Water License Pre-Hearing Technical Meeting Information Supplement

**Doris North Project
Nunavut, Canada**

June 2007

The following supplemental information is provided in response to the Table of Issues generated during the Doris North Pre-Hearing Technical Meeting held in Cambridge Bay on June 11th and 12th, 2007.

Figure 11: Proposed Discharge Point for Treated Greywater

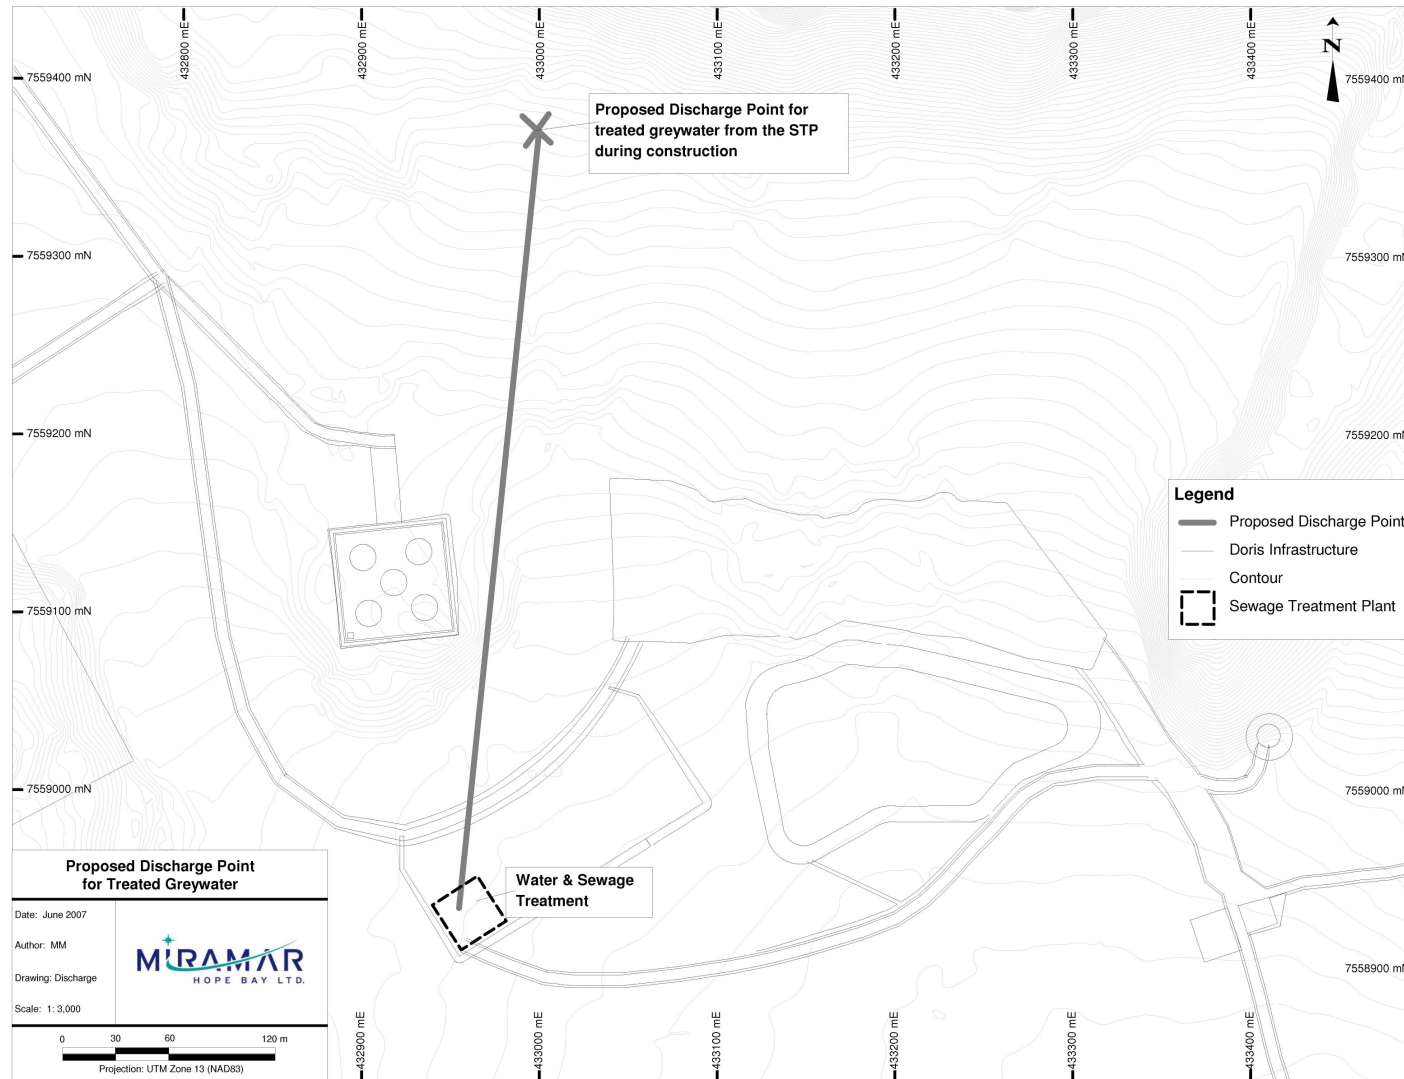
The attached Figure 11 shows the general location of the proposed discharge point for treated greywater from the sewage treatment plant onto the tundra during the construction phase. The discharge point will be armoured with riprap (~300 mm sized rock) to prevent erosion of the tundra (see Drawing G-05 in SD S4 for Riprap gradation specifications).

Figure 12: Spillway Plan and Section

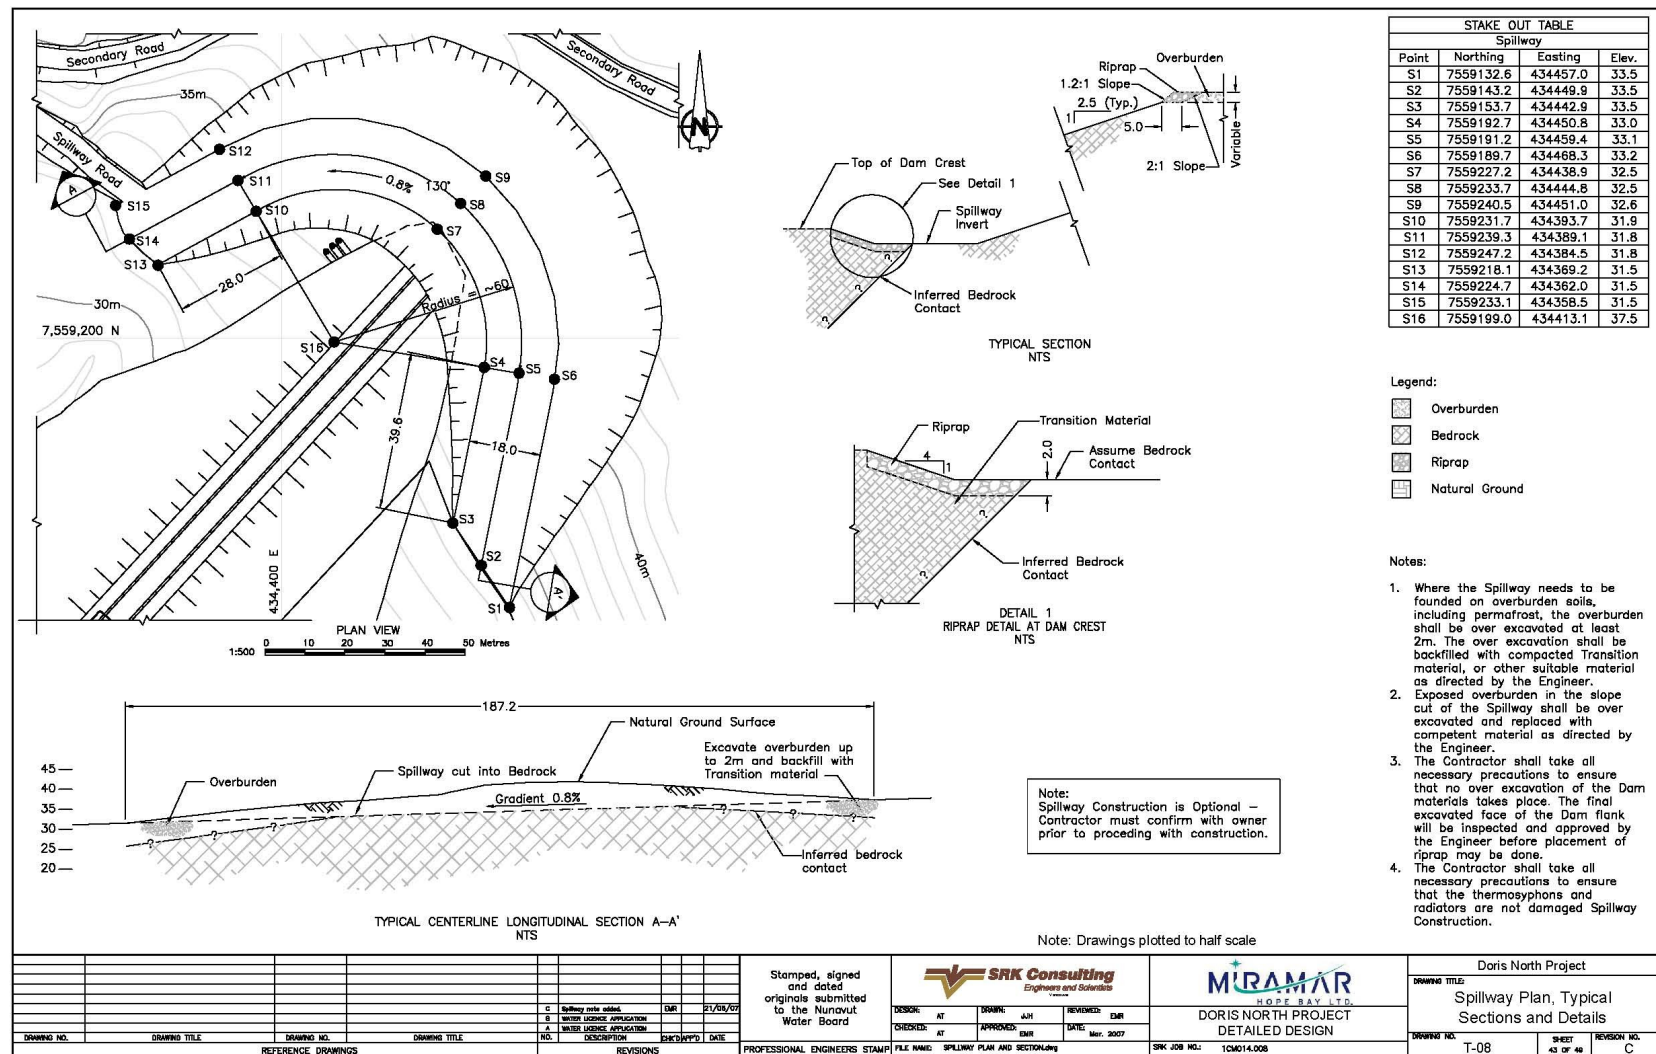
Item # 23 – MHBL to Add Note to Drawing and Specification to Clearly Indicate that Spillway Construction at North Dam is a Contingency Measure

A note has been added to SRK Drawing T-08 (Spillway Plan, Typical Sections and Details) to indicate that the spillway is an optional construction item at this point and is not needed until Tail Lake approaches the Full Supply Level. A copy of this revised drawing is added here as Figure 12.

APPENDIX E:
Figure 3.6 Revision

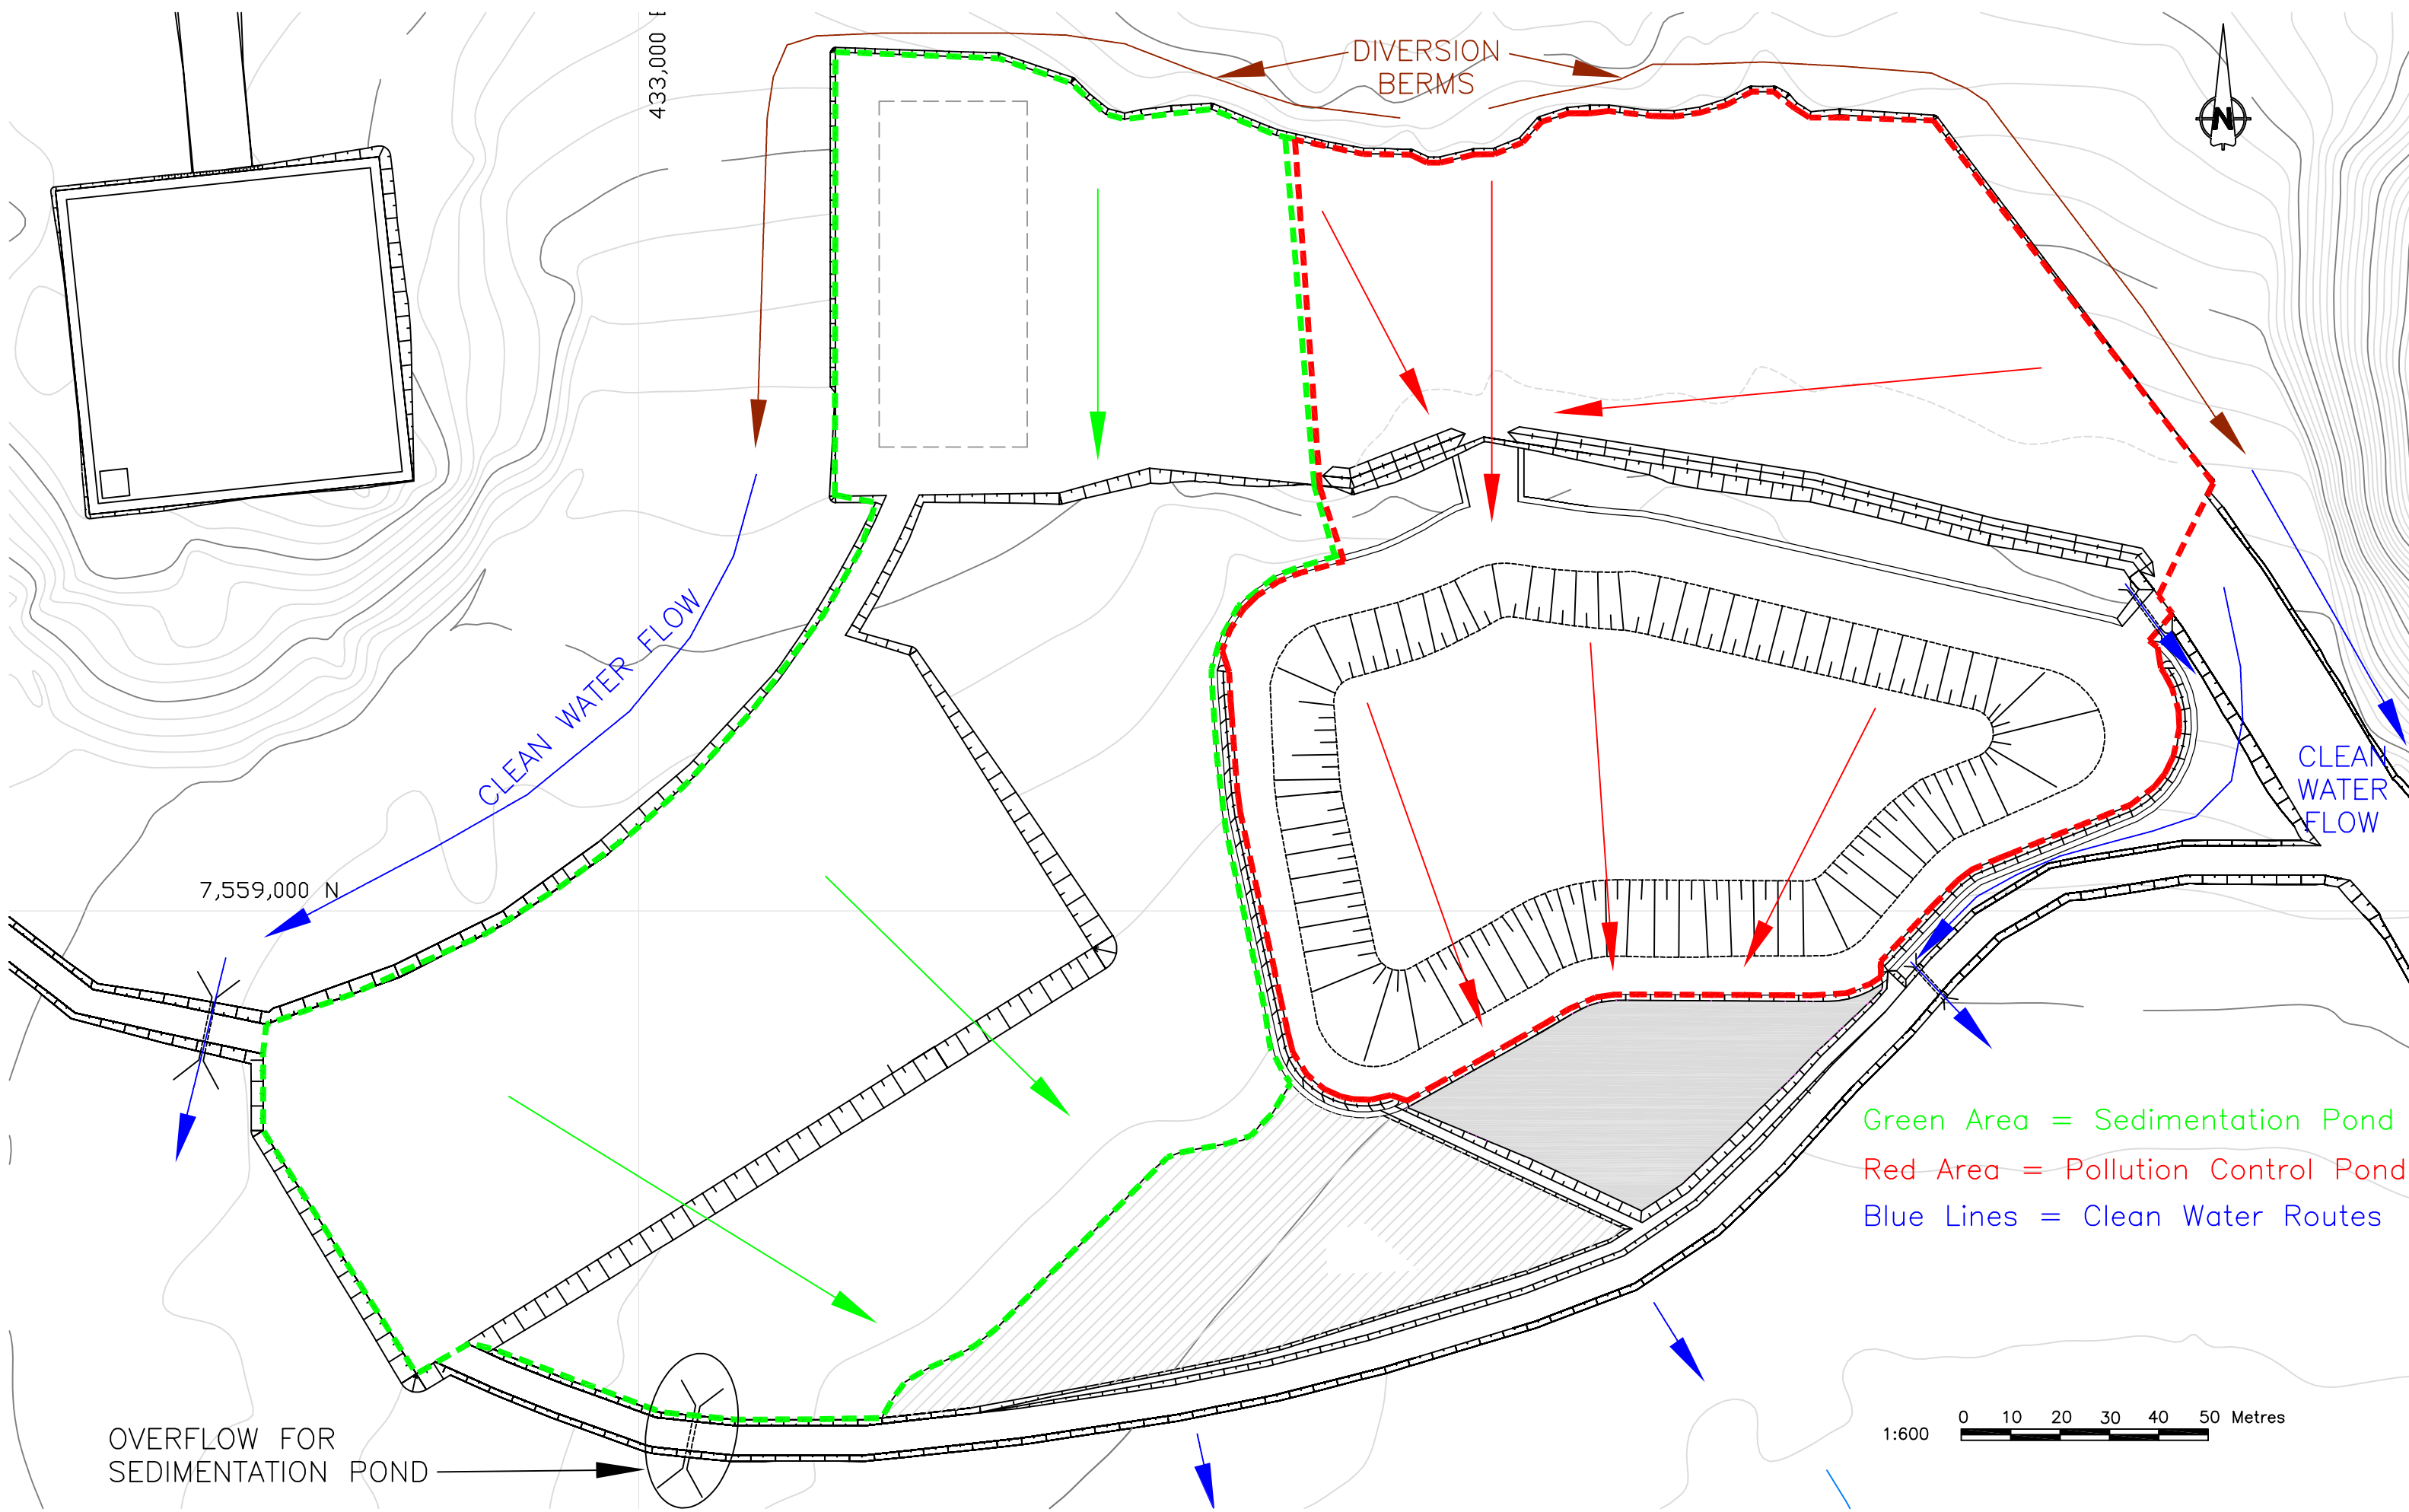
Figure 3.6 “Water Flow Patterns at the Camp and Mill Pad Area (Including the Temporary Waste Rock and Ore Stockpiles)” in Section 3 (Page 167) of the April 2007 Revised Water License Application Support Document has been revised to show that all storm water and snowmelt drainage from the Ore Stockpile and the Temporary Waste Rock Stockpile are collected within the Pollution Control Pond and then pumped to Tail Lake via the mill tailings pump box. The revised Figure is attached to this addendum as Appendix E. This same figure appears as Figure 6.1 in the April 2007 Water Management Plan for the Doris North Project (SD S10j Page 23). Both figures should be replaced by the revised figure attached here as Appendix E. Through this revision MHBL is committing to collect all storm water and snowmelt from the ore and temporary waste rock stockpile areas as well as the crushing plant and mill yard areas and direct this water into the pollution control pond. SRK has confirmed that the pollution control pond as designed still has capacity to contain the 1:100 year storm event of 24 hour duration plus an additional freeboard of 0.3 m for this larger drainage area.
